Docket Nos.: 52-025
52-026

ND-14-0562
10 CFR 50.90
10 CFR 52.63

Southern Nuclear Operating Company
Vogtle Electric Generating Plant Units 3 and 4
Request for License Amendment and Exemption Regarding:
Annex and Radwaste Building Changes (LAR-13-019)

UFSAR Figure 9.4.8-1, Radwaste Building HVAC System

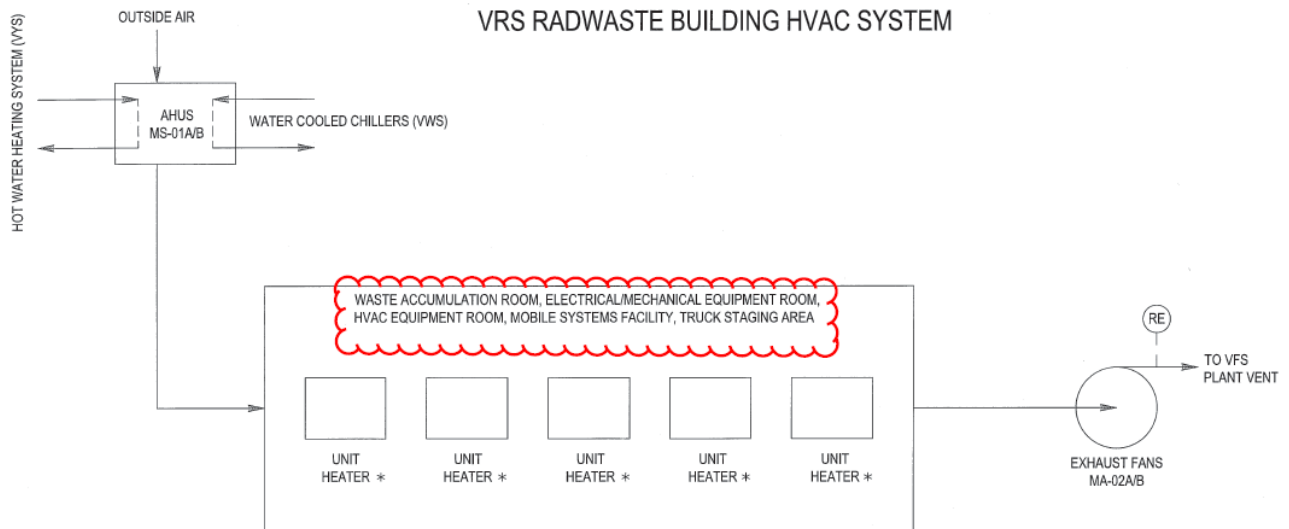
The radwaste building HVAC system serves the radwaste building which includes the clean electrical/mechanical equipment room and the potentially contaminated HVAC equipment room, ~~the packaged waste storage room,~~ the waste accumulation room, and the mobile systems facility.
